# Revisit Alert Signaling

Contribution to IEEE 802.3cy

Marvell

May 3, 2022

Figure 149–20—EEE transmit state diagram

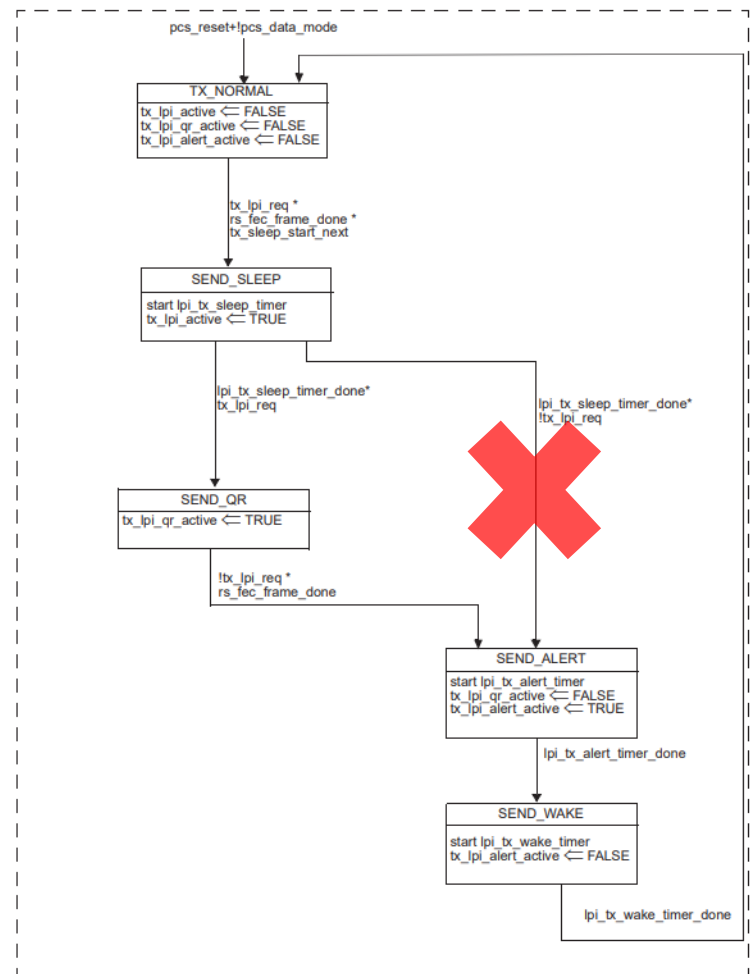
- Eliminating this transition would simplify internal state machines and make interoperability more reliable
- Once we enter Low Power Mode, it may take up to 8 RS-FEC frames before then next alert signal can be sent
- Is faster reaction really needed when exiting SEND\_SLEEP?

Figure 149-20—EEE transmit state diagram

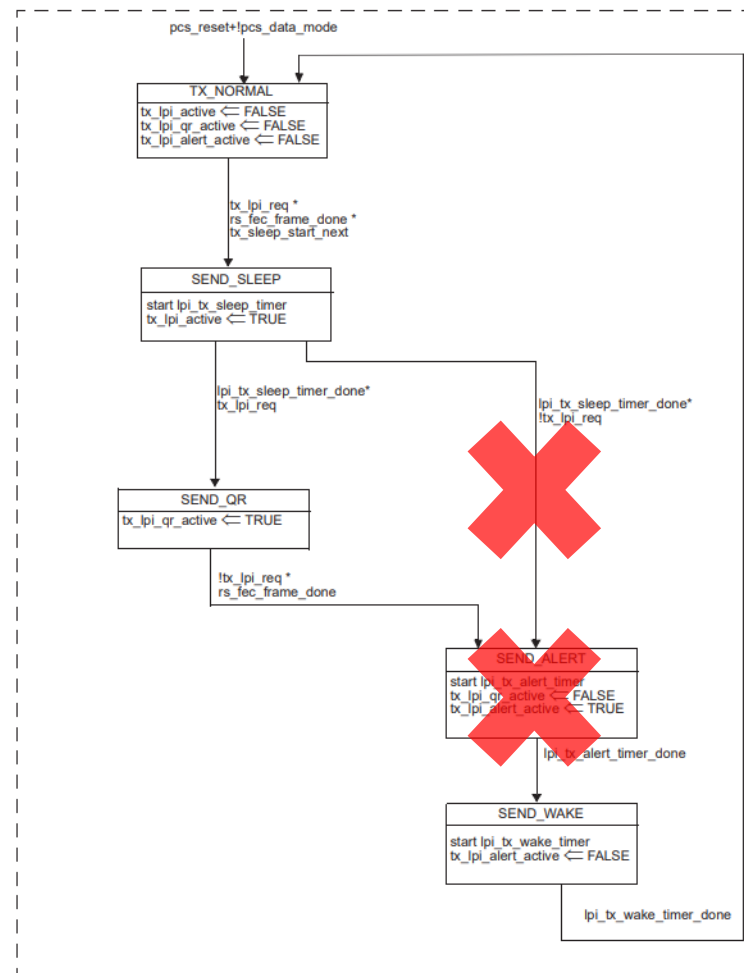
- The EEE transmit state diagram (Figure 149-20) should be updated
  - to remove the SEND\_ALERT state and have the SEND\_QR state transition directly into SEND\_WAKE
  - To remove the path directly from SEND\_SLEEP to SEND\_ALERT
- All reference to separate Alert Signal should be removed
- The Wake Signal may need to be updated and made longer

Figure 149–20—EEE transmit state diagram

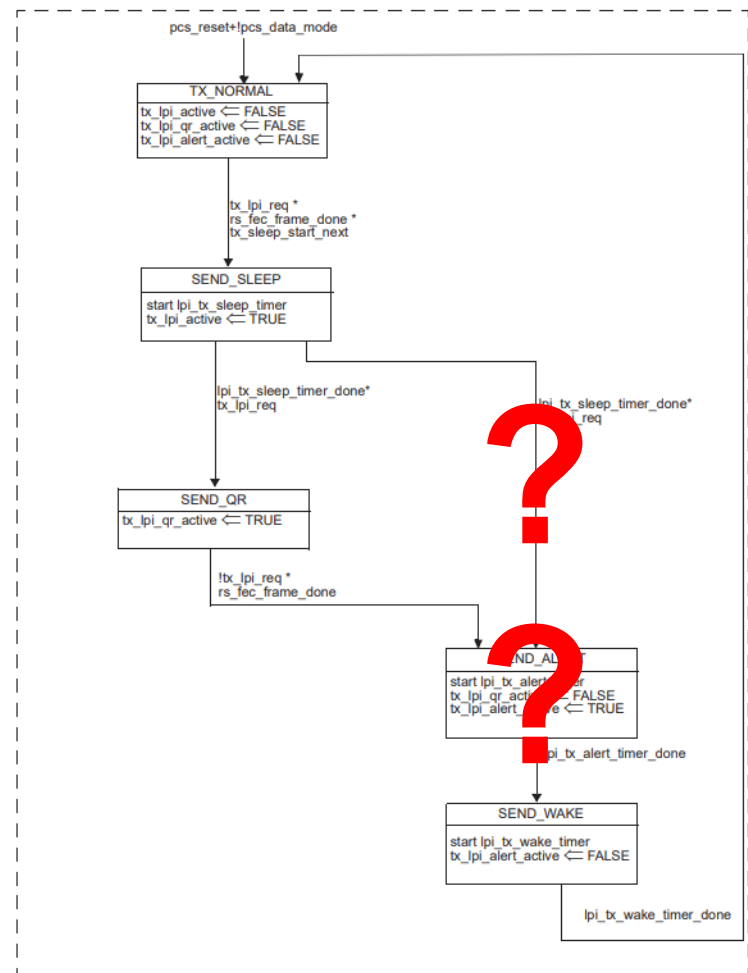
- Is there any value in having separate Alert Signal?
- Are there any inherent problems with detecting the Wake Signal when in low power mode?
- Are there any updates needed to the Wake Signal if we eliminate the Alert Signal?
- Is there any value in having the direct transition from SEND\_SLEEP to SEND\_ALERT/SEND\_WAKE?
